Vertex Innovative Apparels Ltd. (10524)

H.B. Intimates (11786)

Forkan Tower, 360/A, Bitak Bazar, Sagorika, Pahartoli Thana, Chittagong

15.MARCH.2014

Low Column Safety Factors

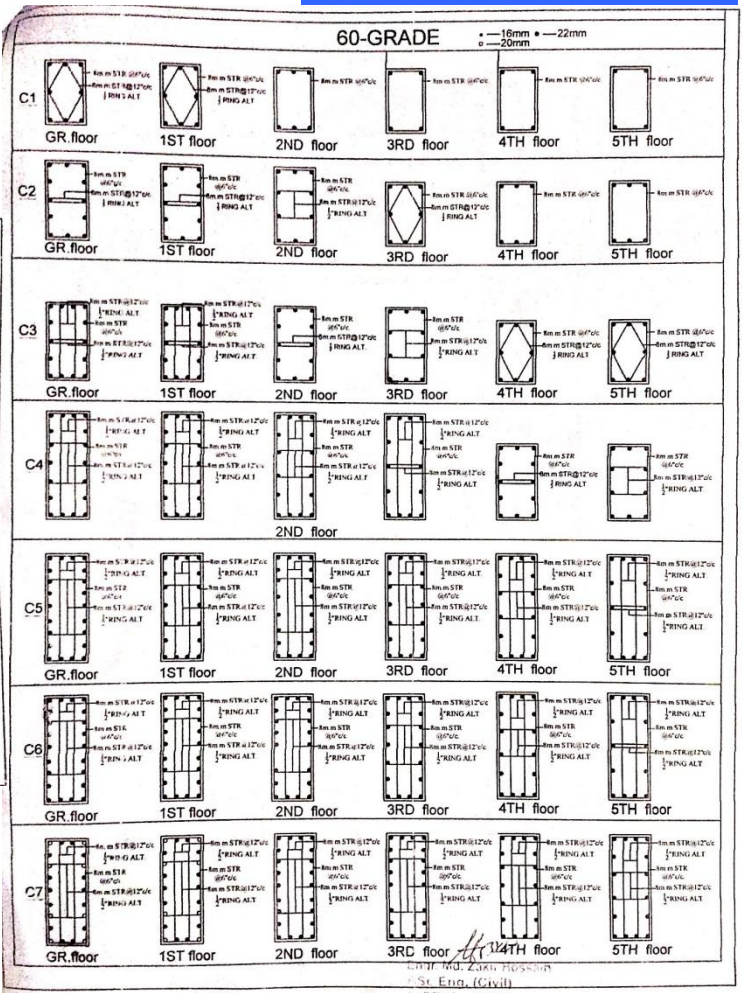
Column load run-downs indicate lower than desirable column safety factors.

- Do not continue construction past the 5th floor slab level. It is recommended that the 5th floor slab be used as the roof level.

- Factory engineer to review design, loads and column stresses.

- Produce and actively manage a loading plan for all floor plates giving consideration to slab and column capacity.

Soil Capacity/Footing Design & Incomplete Structural Drawings

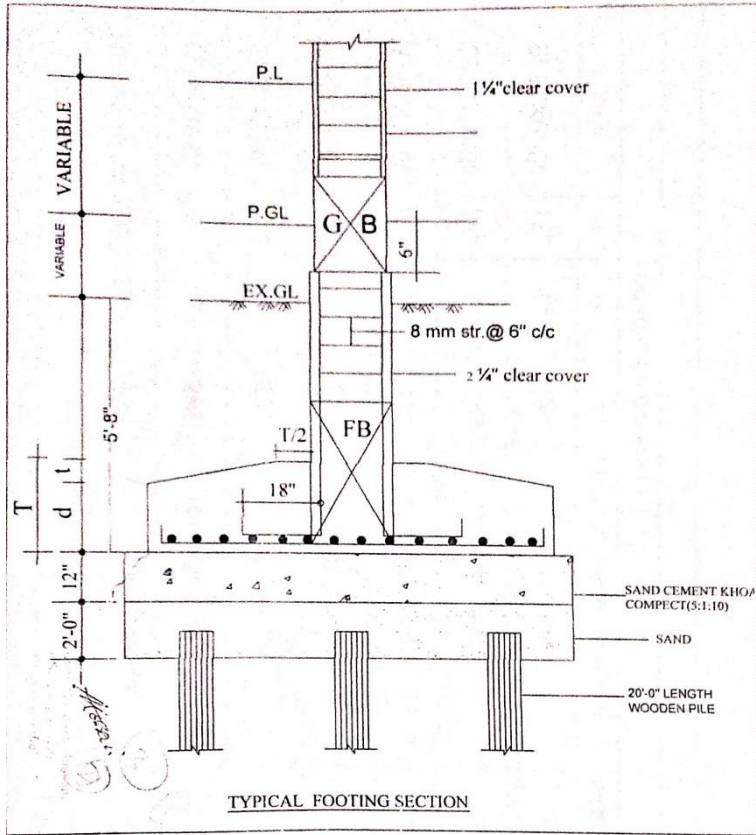
Foundations are built in a manner other than that recommended by the geotechnical report. General foundation capacity checks were performed. Based upon Geotechnical findings, the soil bearing capacity does not appear adequate to support the foundation shown on the structural drawings.

- A Detailed Engineering Assessment to be conducted in order to determine the adequacy of the as-built foundation for existing soil properties

- Carry out any remedial measures recommended by above mentioned detailed engineering assessment.

Incomplete Structural Drawings

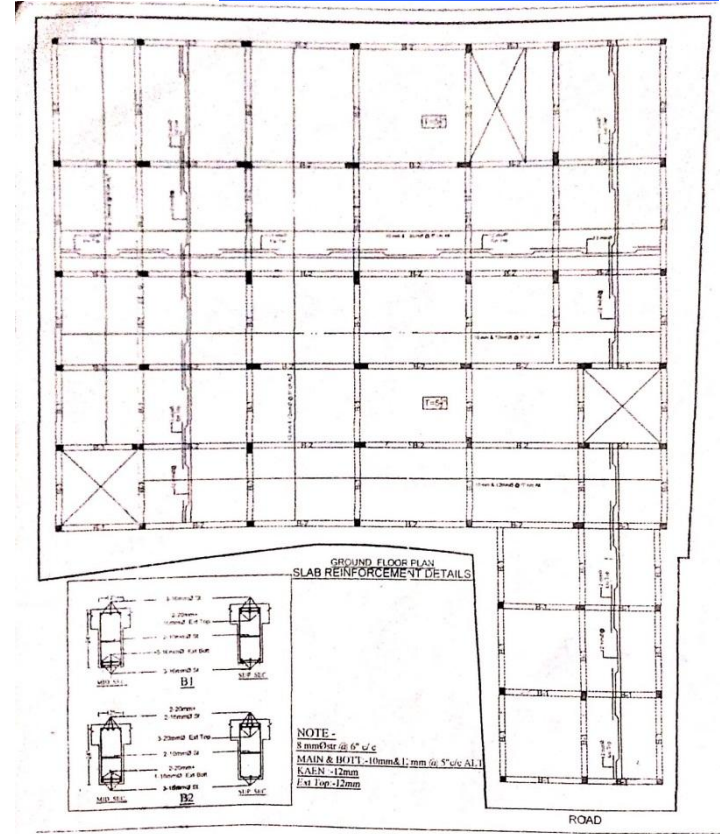
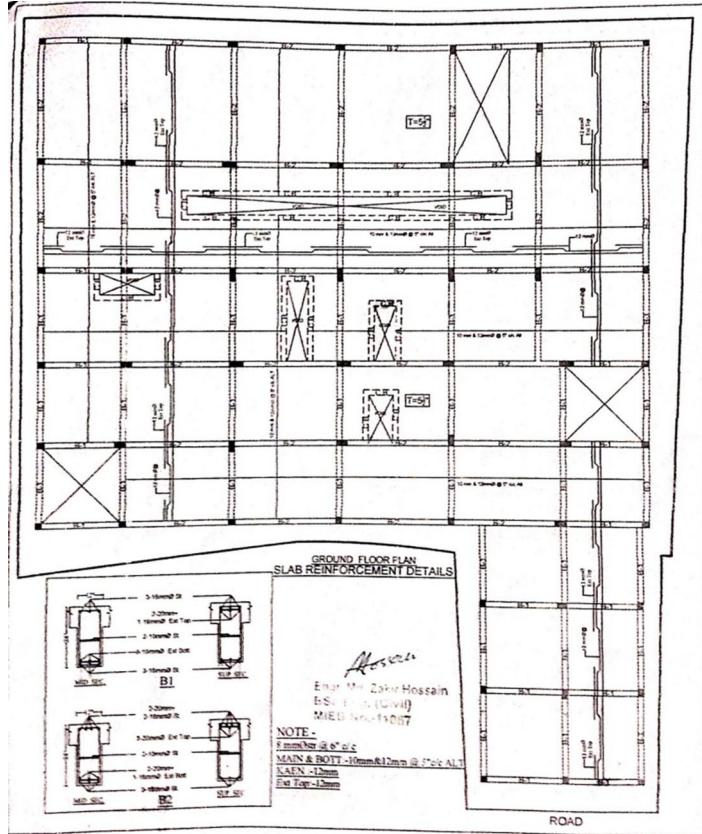
Structural drawings are incomplete. Typical slab reinforcing and roof slab reinforcing plans are missing. Two differing ground floor slab plans are presented. Plans are generally of very poor quality.

- A Detailed Engineering Assessment to be carried out in order to adequately formulate structural plans and assess the suitability of as-built structural elements

- Address findings and recommendations of the above mentioned detailed engineering assessment
